Subject: Firmware History - Main Unit Controller		Prepared by: H.K.	
From: 1st Tech. Support Sec. Service Support Dept.			
Classification:	<input type="checkbox"/> Troubleshooting	<input type="checkbox"/> Part information	<input type="checkbox"/> Action required
	<input type="checkbox"/> Mechanical	<input type="checkbox"/> Electrical	<input type="checkbox"/> Service manual revision
	<input type="checkbox"/> Paper path	<input type="checkbox"/> Transmit/receive	<input type="checkbox"/> Retrofit information
	<input checked="" type="checkbox"/> Other (Firmware History)

Model: Model PL-MF		Date: 22-Dec-06	No.: RG157003
Subject: ADF Jam or skew (US & European versions only)		Prepared by: H.K.	
From: 1st Tech. Support Sec. Service Support Dept.			
Classification:	<input checked="" type="checkbox"/> Troubleshooting	<input type="checkbox"/> Part information	<input checked="" type="checkbox"/> Action required
	<input type="checkbox"/> Mechanical	<input type="checkbox"/> Electrical	<input type="checkbox"/> Service manual revision
	<input type="checkbox"/> Paper path	<input type="checkbox"/> Transmit/receive	<input checked="" type="checkbox"/> Retrofit information
	<input type="checkbox"/> Pr

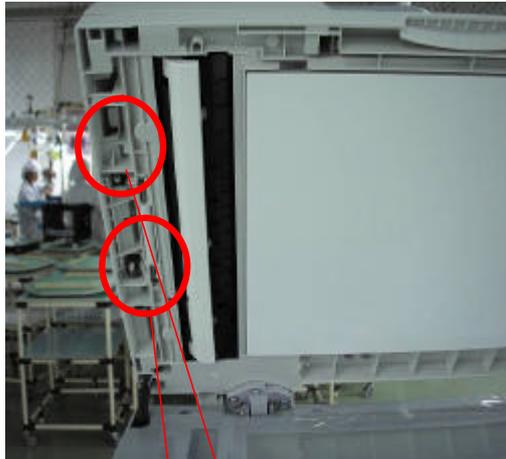
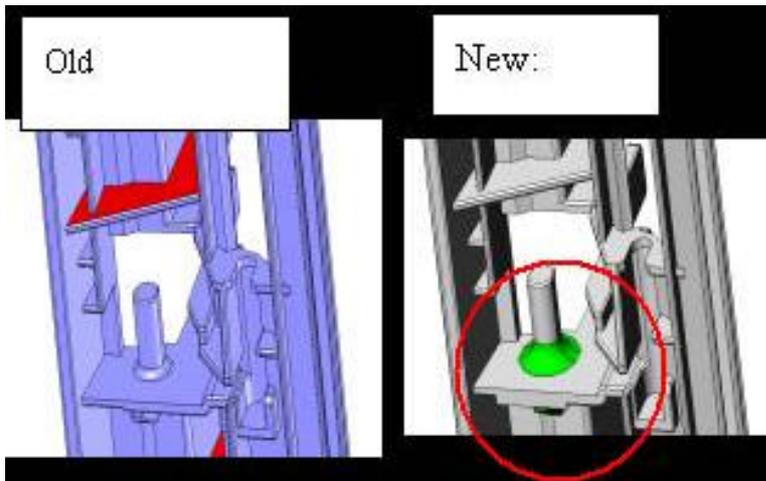
Original jam or skew occurs.

The rib near the pin on which the roller spring is anchored breaks (see the picture below), which is due to a manufacturing error and insufficient strength of the part.

1. The thickness of the rib has been changed from 1.5 mm to 2.0mm.
2. The foot of the pin has been strengthened as shown below.
3. An inspection procedure using a double strength spring (compared to the actual production spring) has been added to the production process.

Inspection

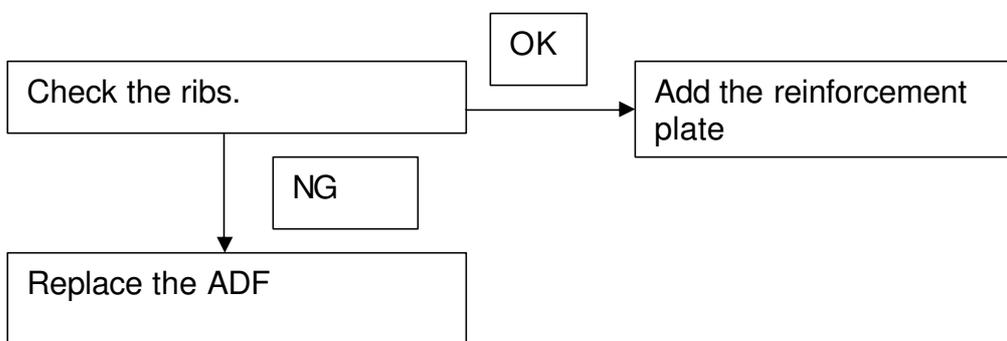
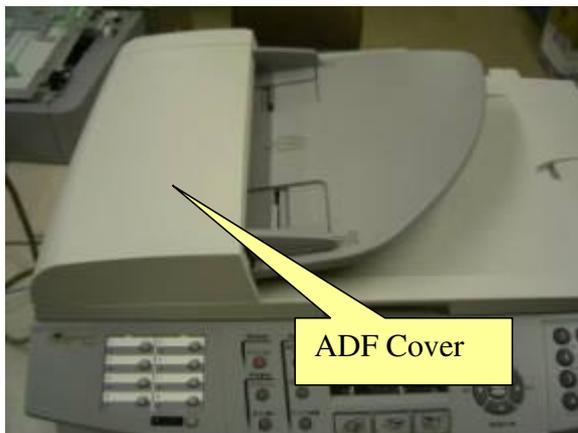
When the ribs near the pins are NG (No Good or defective), the ADF should be replaced.
When the ribs are OK, add the reinforcement plate to ensure the function of the pin.

1. Open the ADF unit.
2. Push the ribs lightly by finger to check whether the ribs are broken.
3. When neither of the ribs break, add the reinforcement plate. If either one of the two ribs breaks (or is already broken), then replace the ADF.

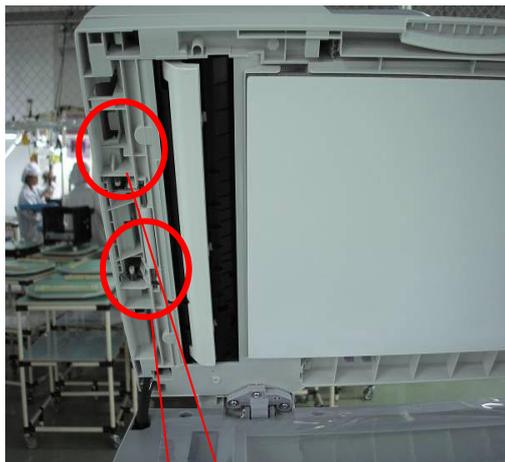
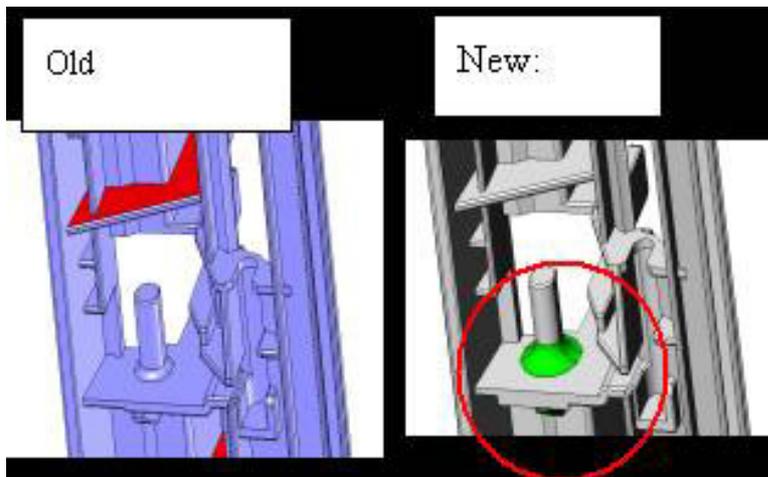
Original jam or skew occurs.

The rib near the pin on which the roller spring is anchored breaks (see the picture below), which is due to a manufacturing error and insufficient strength of the part.

1. The thickness of the rib has been changed from 1.5 mm to 2.0mm.
2. The foot of the pin has been strengthened as shown below.
3. An inspection procedure using a double strength spring (compared to the actual production spring) has been added to the production process.
4. **A reinforcement plate was added to machines from July 2007 production (P/N V121379: Reinforcement Plate Kit).**

- **Install the reinforcement plate on the affected units for service calls reported from the field.
SEE THE PROCEDURE BELOW.**

- **The previous RTB recommended replacing the ADF, but it was found that this symptom can be solved by installing the reinforcement plate alone.**
- **The reinforcement plate supports the spring directly, so that the pin does not have to.**

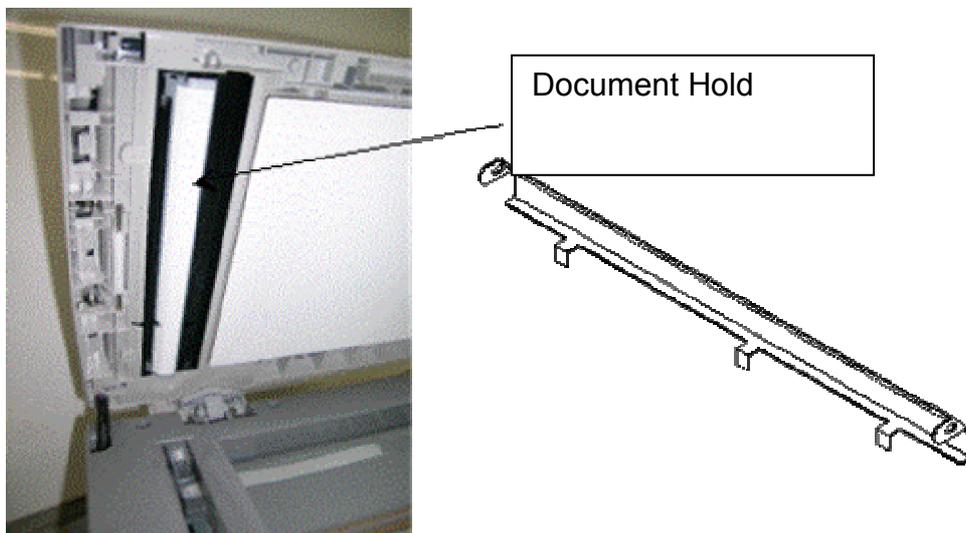
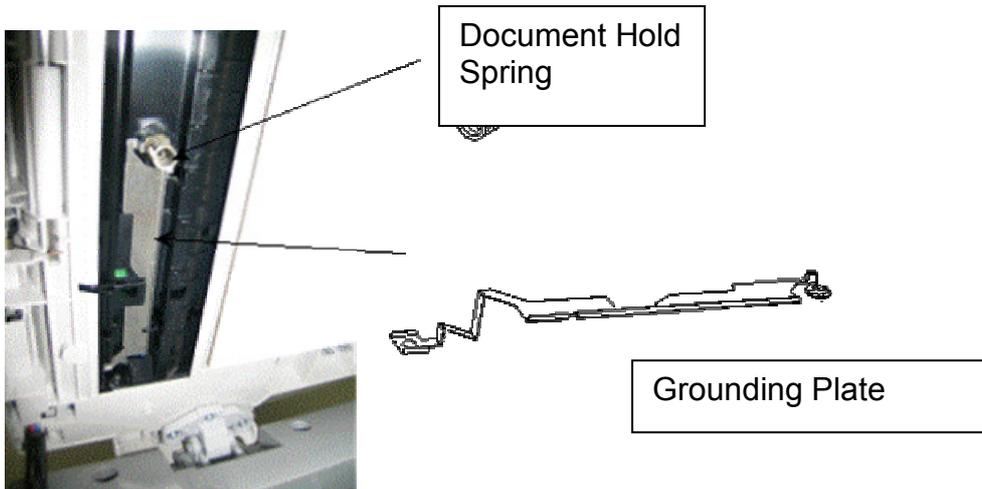
Vertical black lines appear on the image if 40 or more originals are scanned consecutively in the ADF under low-humidity conditions.

Scanning this many originals tends to cause a build-up of static electricity on the separation pad and feed rollers. This charge is transferred to the paper surface and original holder, and then eventually to the CIS. As a result, the CIS malfunctions and produces the black lines.

If this symptom occurs, attach the parts in the new “Document Hold Supply Assembly” (P/N **V121387**) to the ADF.

- The material of the original holder (pg. 19, index 25) was changed from a polymer to metallic material, in order to increase the grounding of the holder.
- A grounding plate was added.
- The number of individual coil rings of the document hold spring (pg. 19, index 26) was reduced from 10 to 6.
